Inspection Photos

API: 017-06636

Operator: **WILLIFORD ENERGY COMPANY**

Inspection Date: 1/28/2025

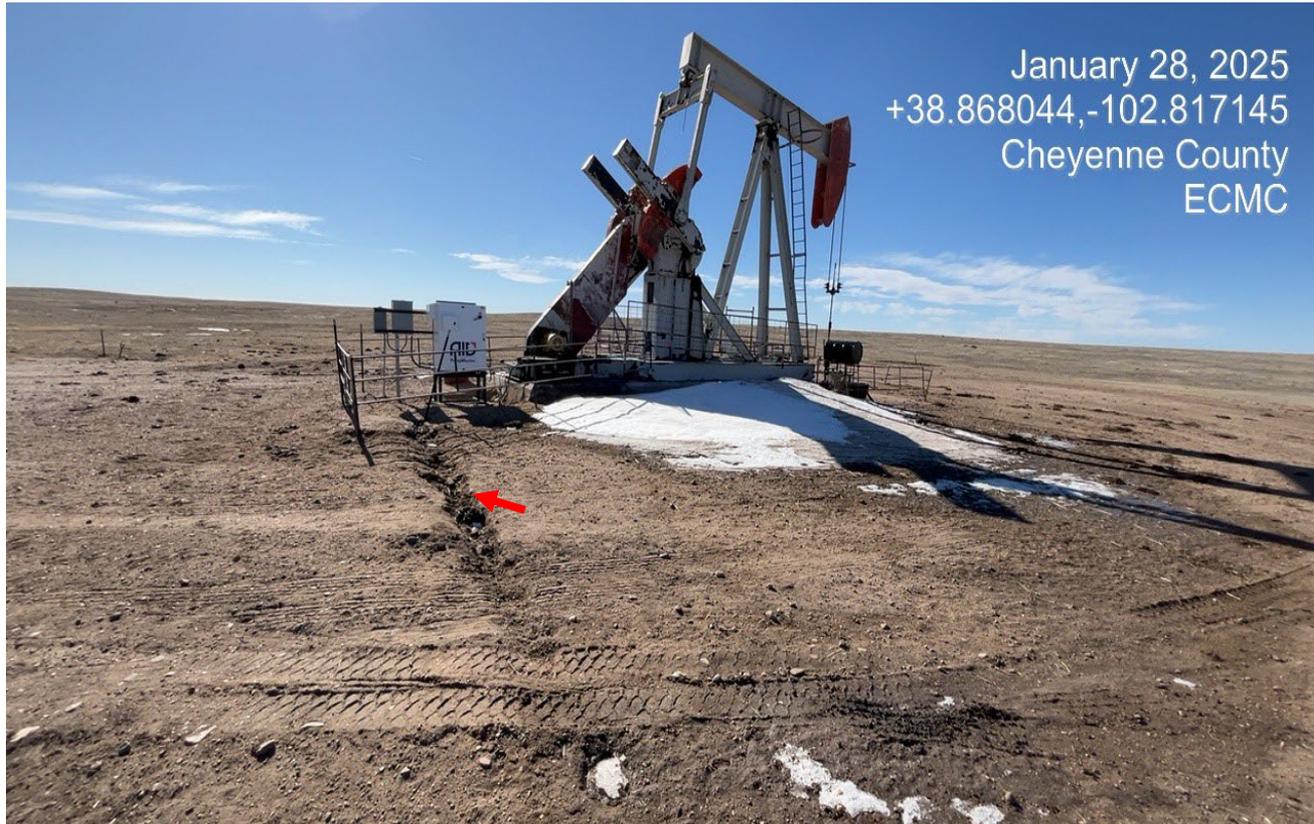
Photo 4. Facing toward the wellsite. The pumpjack engine has been replaced with an electric motor. The trench is shown at red arrow and needs to be filled in. The disturbance to the electric line needs to be reclaimed.

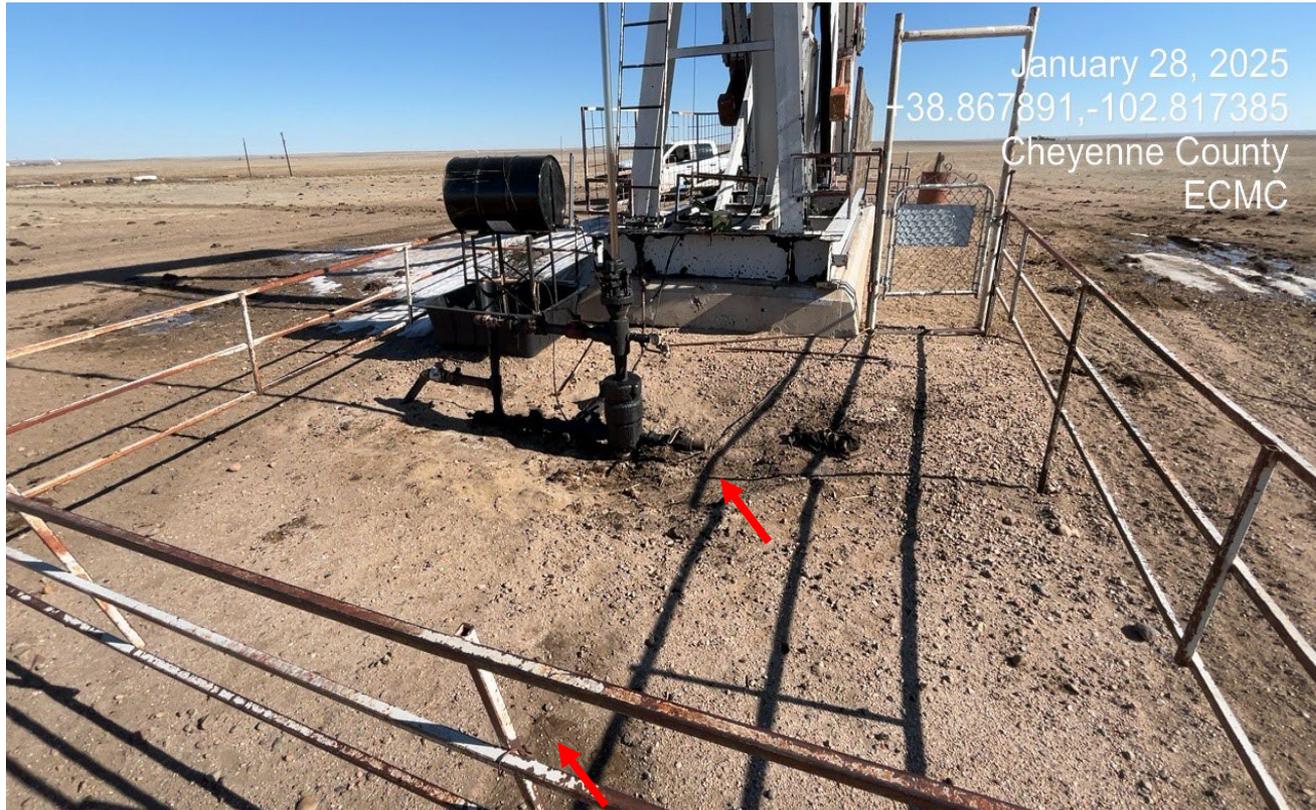
Photo 5. There is oil stained soils at the wellhead that need to be cleaned up and properly disposed.

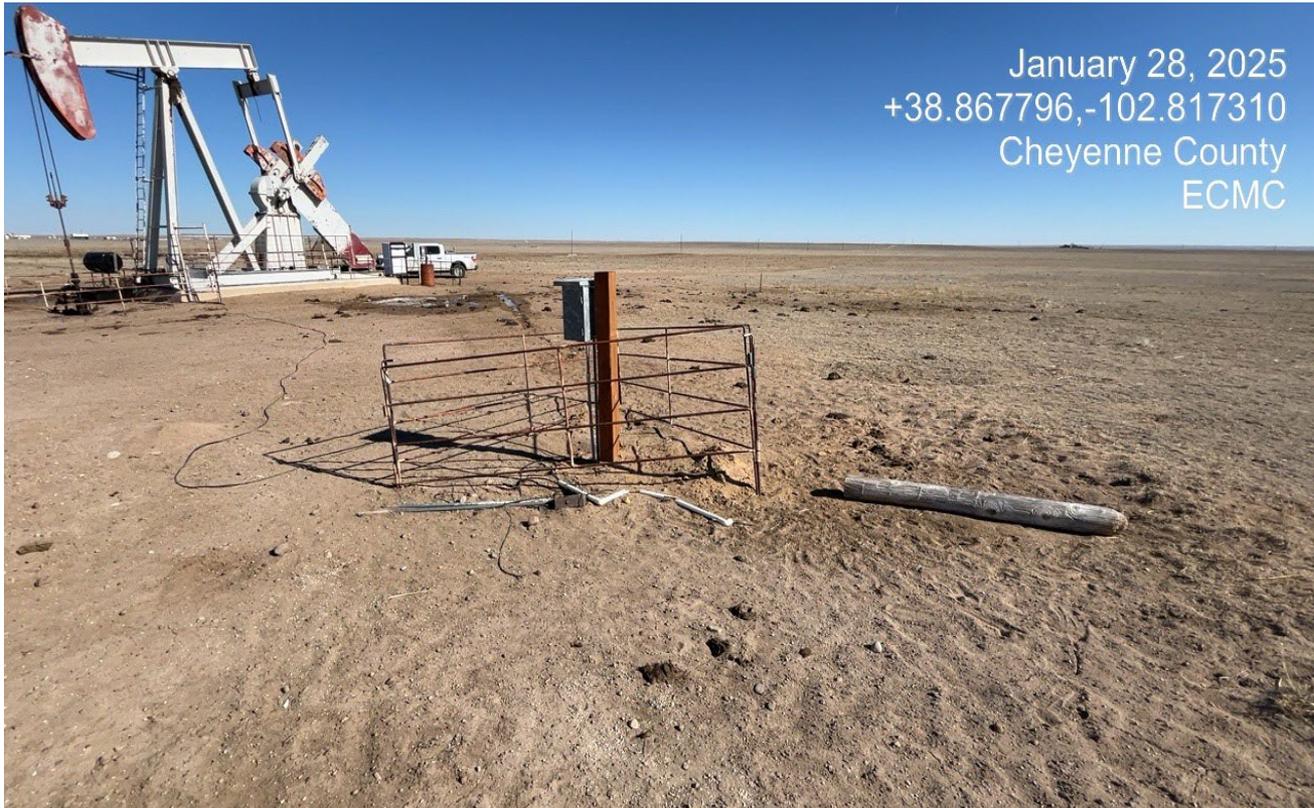
Photo 7. Facing toward the electric utility just south of the well. The electric utility was repaired but the wire and debris on the ground needs to be removed.
